CITY PLANNING COMMISSION

- APPLICATION:
1. Negative Declaration
 2. Rezone vacant 10.4± acres from Garden Apartment (R-2B-PUD) to Townhouse (R-1A) (Sec. 13).
 3. Tentative Map to resubdivide 10.4 vacant acres into 81 zero lot line single family lots;
 4. Special Permit to construct 81 zero lot line units (Sec. 7-C).

LOCATION: West side of Truxel Road, 500 feet north of San Juan Road

TENTATIVE MAP of
 RESUBDIVISION of LOTS 4 and 12 THRU 26 of
 RESUBDIVISION of VILLA SAN JUAN CONDOMINIUMS (ISO B.M. 12)
VILLA SAN JUAN
 CITY OF SACRAMENTO, CALIFORNIA
 FEBRUARY 1984 SCALE: P-50
 MURRAY SMITH AND ASSOCIATES

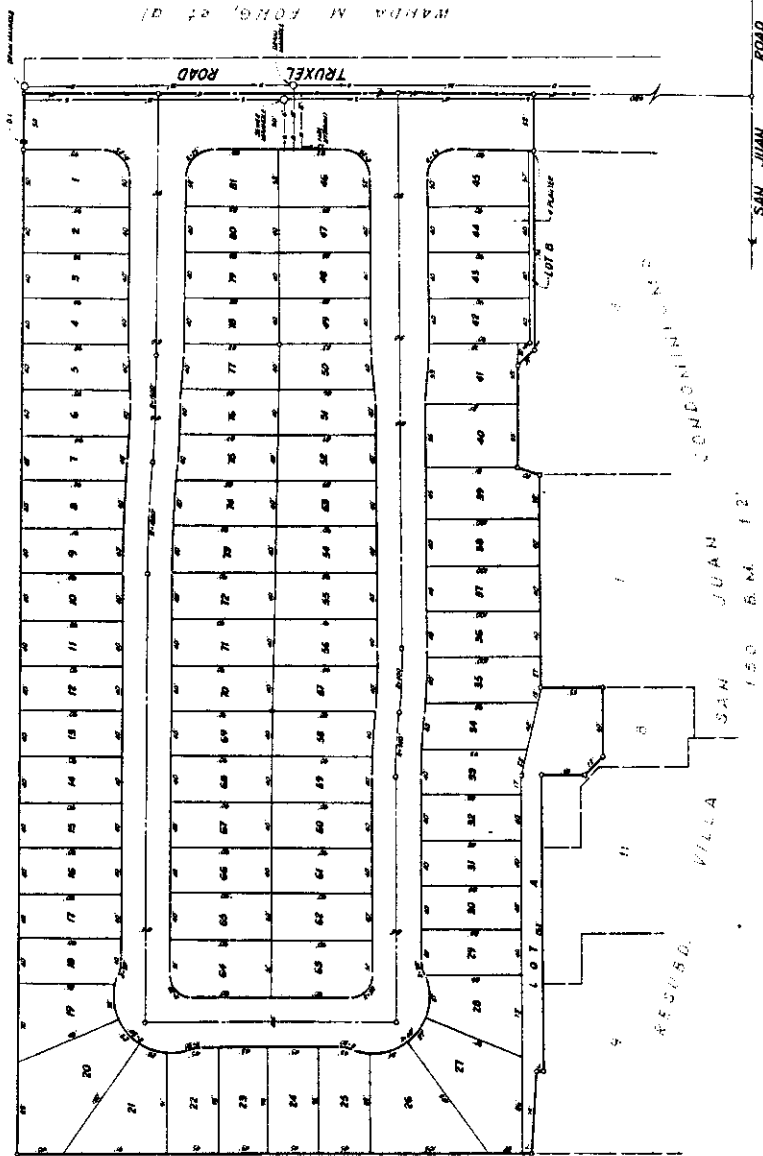
- j. Show existing water line easement on lot 27. Extend water line up to and connect with water line in the proposed street;
- k. Relocate lot line between lots 27 and 28 to coincide with the existing water line.

1. The proposed project provides an adequate range of unit sizes (750 to 1,250 s.f.) and elevations (3 for each of 4 models).
2. The resubdivision of the northerly portion of the original 20 acres modifies the on-site circulation of the original condo development. A turnaround will need to be provided to insure adequate fire access. The specific details of the turnaround can be resolved with the Fire Department prior to recordation of the map.

3. Lots A and B are remainder lots that will become part of the condo site. Staff requests that these lots be combined with the condominium site.
4. County Health indicates the zero lot line projects can have noise problems from mechanical equipment. Thus, there is a need for quiet units with sound shielding to comply with the noise ordinance.

- h. Provide easements for existing SMUD utilities;
- i. Complete a lot line adjustment process to merge parcels A and B with the condominium common property to the south;
- j. Show existing water line easement on lot 27. Extend water line up to and connect with water line in the proposed street;
- k. Relocate lot line between lots 27 and 28 to coincide with the existing water line;
- l. A turnaround shall be provided on the adjacent condominium site on the south to insure adequate access and turnaround for fire trucks to the satisfaction of the Fire Department prior to recordation of the final map.

1. On-site access for the original condo site shall be provided to the satisfaction of the Fire Department.
2. Mechanical equipment shall be "quiet units" with sound shielding satisfactory to the County Health Department.
3. Site plans and elevations shall be reviewed and approved by planning staff prior to issuance of building permits.
